Product Safety Recall

N212340980 Rear Toe Link Separation

Release Date: December 2021 **Revision:** 03
Revision Description: This bulletin has been updated in the warranty and service procedure sections. Please discard all previous copies of N212340980.

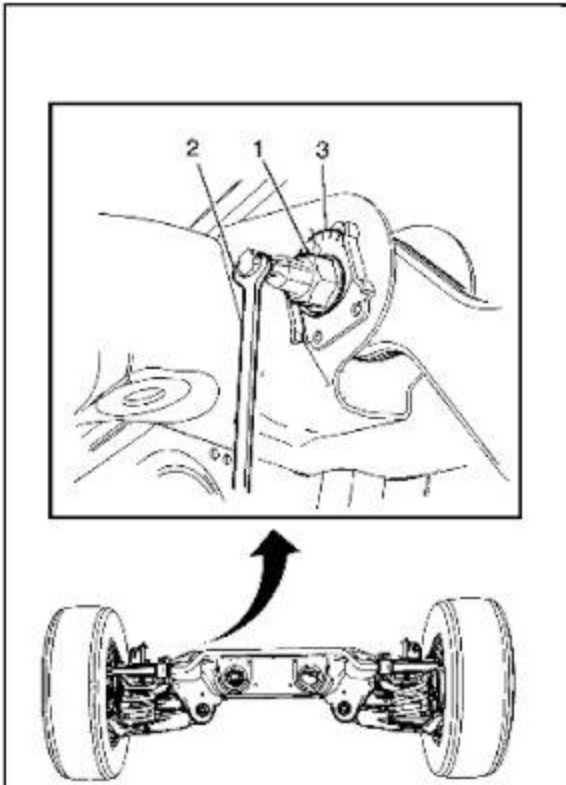
2. If installing the over-mold part, record the serial numbers from BOTH new suspension links on the job card (not required for the solid link service part).

3. Install the new left and right rear suspension links. Refer to *Adjust Link Replacement* in SI (NOTE: over-mold service part shown, solid link part installation is the same).
4. Set the Front and Rear Alignment, refer to *Wheel Alignment - Steering Wheel Angle and/or Front Toe Adjustment and Rear Camber Adjustment* in SI.
